Subject: Issuance of Amendment No. 75 to Facility Operating License NPF-9
and Amendment No. 56 to Facility Operating License NPF-17 - McGuire
Nuclear Station, Units 1 and 2 (TACs 65437/65438)

AMENDMENT NO. 75 TO FACILITY OPERATING LICENSE NPF-9 - McGuire Nuclear Station, Unit 1
AMENDMENT NO. 56 TO FACILITY OPERATING LICENSE NPF-17 - McGuire Nuclear Station, Unit 2

SAFETY EVALUATION BY THE OFFICE OF NUCLEAR REACTOR REGULATION
RELATED TO AMENDMENT NO. 75 TO FACILITY OPERATING LICENSE NPF-9
AND AMENDMENT NO. 56 TO FACILITY OPERATING LICENSE NPF-17

FIGURE 5.1-3

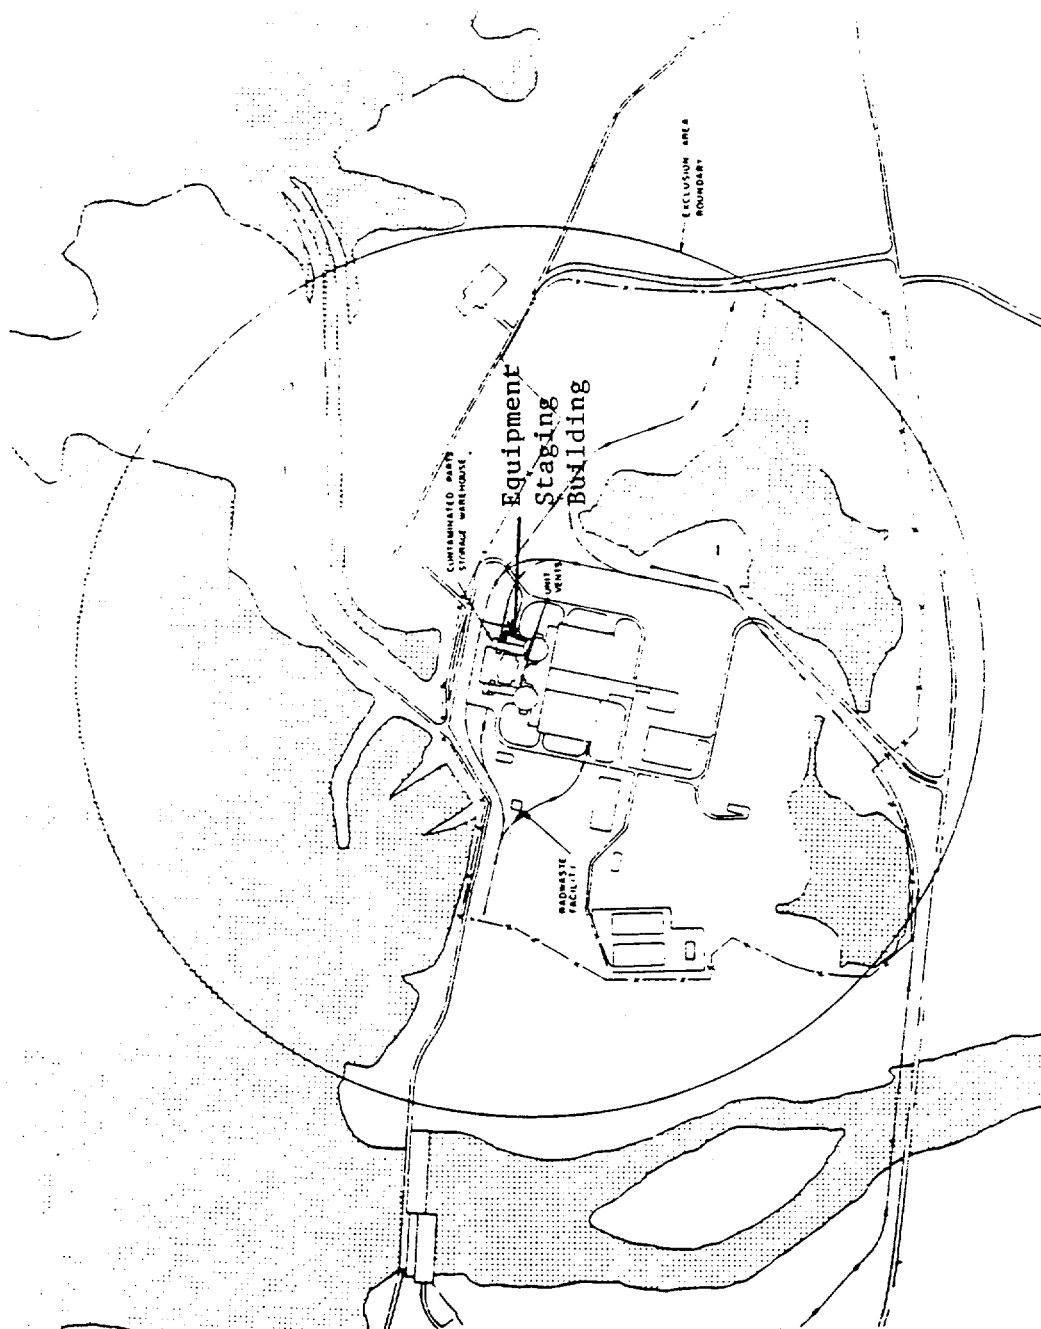
Specifically, TS Figure 5.1-3 "Site Boundary for Gaseous Effluents," which shows locations within the Exclusion Area Boundary for radioactive gaseous effluents released to unrestricted areas, would be revised to reflect the addition of the ESB. Changes to TS Table 3.3-13 "Radioactive Gaseous Effluent Monitoring Instrumentation" would add minimum channel operability requirements applicable during gaseous effluent releases, and associated actions required with the number of operable channels less than specified, for the noble gas activity monitor (EMF-59), flow rate monitor, and sampler minimum flow device of the ESB ventilation system. Similarly, changes to TS Table 4.3-9 "Effluent Monitoring Instrumentation Surveillance Requirements" would add surveillance requirements (channel check, source check, channel calibration frequency, and analog channel operational test frequency) for these same three monitors, applicable at all times except when the ventilation system isolation valve is closed and locked. TS Table 4.11-2 "Radioactive Gaseous Waste Sampling and Analysis Program" would be revised to reflect the addition of the ESB as new item 4c, and to reflect sampling and analysis requirements corresponding to those presently specified for the Radwaste Facility Vent (item 4a) and Contaminated Materials Warehouse (item 4b).

An additional change would correct inconsistent names for the same structure; the reference to "Contaminated Materials Warehouse" in TS Table 4.11-2 (item 4b) and to "Contaminated Parts Storage Warehouse" in Figure 5.1-3 would both be changed to "Contaminated Parts Warehouse."

The change to TS Table 4.11-2 (item 4b) and to TS Figure 5.1-3 to correct the name of the Contaminated Parts Warehouse is a purely administrative change to achieve consistency throughout the TS. It has no adverse safety implication and is, therefore, acceptable.
